RESPONSE TO REQUEST FOR ADDITIONAL INFORMATION

APR1400 Design Certification

Docket No. 52-046

RAI No.: 32-7946
SRP Section: 08.03.01 – AC Power Systems (Onsite)
Application Section: 08.03.01
Date of RAI Issued: 06/16/2015

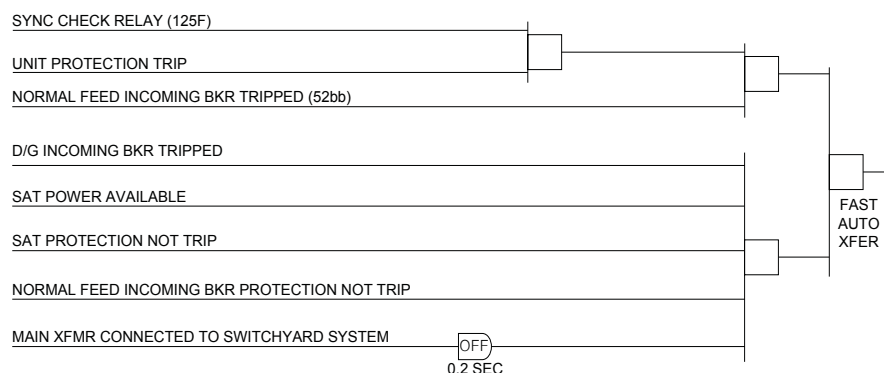
1. How a loss of voltage at any one of the Class 1E buses of one division initiates an automatic fast transfer of the offsite power source to an unaffected bus of another division by switching the affected bus to an unaffected SAT
2. How the automatic transfer to a faulted bus will be prevented

3. For a potential failure in the fast transfer scheme (such as failure of a circuit breaker, or failure of control power), address the vulnerability of the scheme so that the fast transfer scheme failure does not affect the capability of the Class 1E emergency diesel generators (EDG) to perform their safety function of supplying electrical power to the Class 1E emergency buses in a loss of voltage condition
4. Discuss how the automatic fast transfer prevents a bus transfer to an out-of-phase source, and discuss the sync-check logic scheme

A loss of voltage at any Class 1E bus of one division does not initiate the automatic fast transfer of the offsite power source. The automatic fast transfer is initiated only in a case when there is a unit protection trip at the normal preferred power supply (PPS) circuit.

- The unit protection trip due to failure of the unit auxiliary transformers (UATs), isolated phase bus (IPB), generator circuit breaker (GCB), main transformer (MT), or switchyard circuit breakers gives trip signals to the normal feed incoming breakers of all MV buses of both divisions and close signals to the alternate feed incoming breakers of the MV buses.
- For each bus, closing of the alternate feed incoming breaker is permitted by output of the synchro-check relay for fast transfer and the open status of the normal feed incoming breaker and EDG feeder breaker.

For more information, a simplified control logic diagram for the automatic fast transfer is provided below:

If the fast transfer is blocked by the synchro-check relay (125F) output, a residual transfer will be performed automatically when the condition is met.
